DEPARTMENT OF TRANSPORTATION
National Highway Traffic Safety Administration

Federal Motor Vehicle Safety Standards;

Electric-Powered Vehicles: Electrolyte Spillage and Electrical Shock Protection

ACTION: Final rule.

Figure 7b. S4, S5.3, S5.4.1.3, and S5.4.1.4 Jointed test finger IPXXB

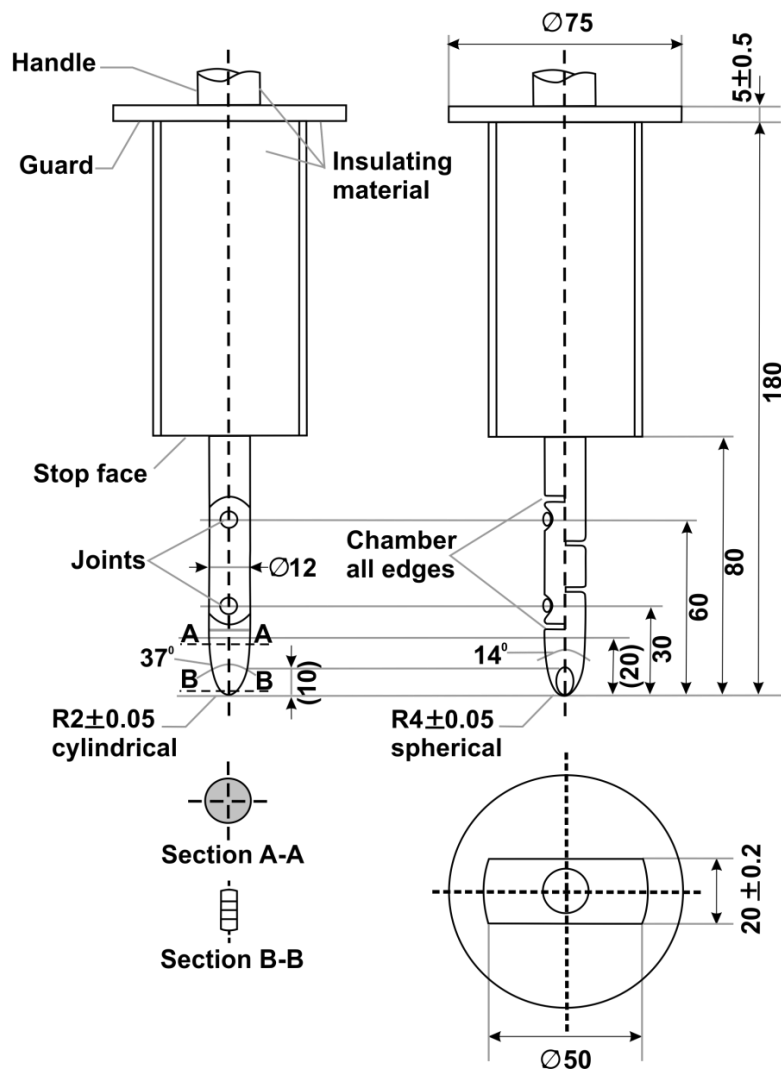
We make a minor correction to Figure 7b and clarify Figure 8.

The proposal provided specifications of the IPXXB probe in Figure 7b of the regulatory text. The Alliance and Global note errors in the specification for R2 and R4. The agency has corrected the errors in Figure 7b.

Figure 8. S9.2 Connection to determine resistance between exposed conductive parts of electrical protection barrier and electrical chassis

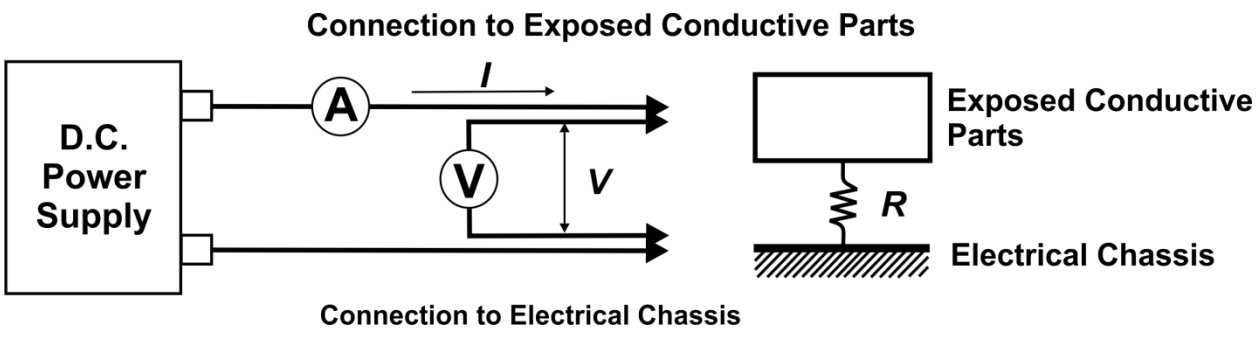
The Alliance and Global provide an improved Figure 8 in which the text is clearer than the NPRM's Figure 8. The agency has included the new figure in FMVSS No. 305.
